ORDINANCE NO. 2017-04-06

AN ORDINANCE OF THE CITY OF LANCASTER, TEXAS, REPEALING THE CODE OF ORDINANCES 2012 EDITION IN ITS ENTIRETY AND REPLACING IT WITH THE ADOPTION OF THE INTERNATIONAL RESIDENTIAL CODE, 2015 EDITION BY ADOPTING CHAPTER 6, ARTICLE 6.04, DIVISION 3, RESIDENTIAL CODE, TO PROVIDE FOR THE AMENDMENTS TO THERETO; PROVIDING A PENALTY OF FINE NOT TO EXCEED TWO THOUSAND DOLLARS (\$2,000.00); PROVIDING FOR SEVERABILITY; PROVIDING FOR SEVERABILITY; PROVIDING A SAVINGS CLAUSE; PROVIDING A REPEALING CLAUSE; AND PROVIDING FOR AN EFFECTIVE DATE.

FIGURE R602.6.1
TOP PLATE FRAMING TO ACCOMMODATE PIPING

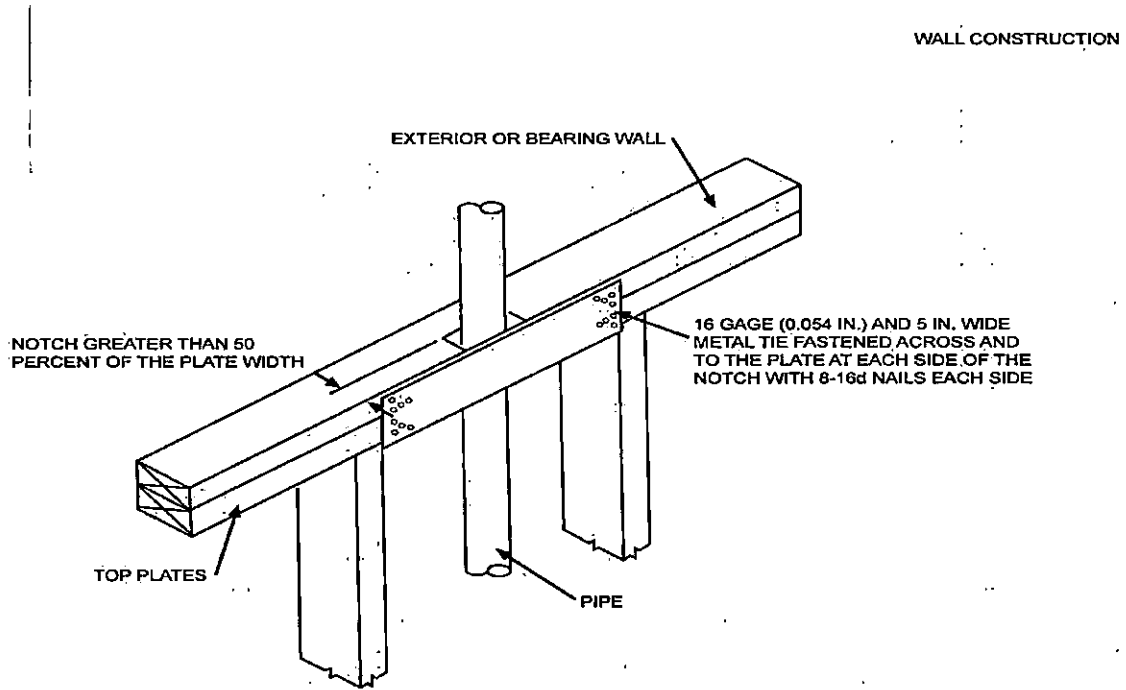
To amend Figure R602.6.1 by deleting the figure and add the following figure:

“R602.6.1 Drilling and notching of top plate. When piping or ductwork is placed in or partly in an exterior wall or interior load-bearing wall, necessitating cutting, drilling or notching of the top plate by more than 50 percent of its width, a galvanized metal tie not less than 0.054-inch-thick (1.37 mm) (16 Ga) and 5 inches (127 mm) wide shall be fastened across and to the plate at each side of the opening with not less than eight 10d (0.148-inch diameter) having a minimum length of 1 ½ inches (38 mm) at each side or equivalent. Fasteners will be offset to prevent splitting of the top plate material. The metal tie must extend a minimum of 6 inches past the opening. See figure R602.6.1. {remainder unchanged}”
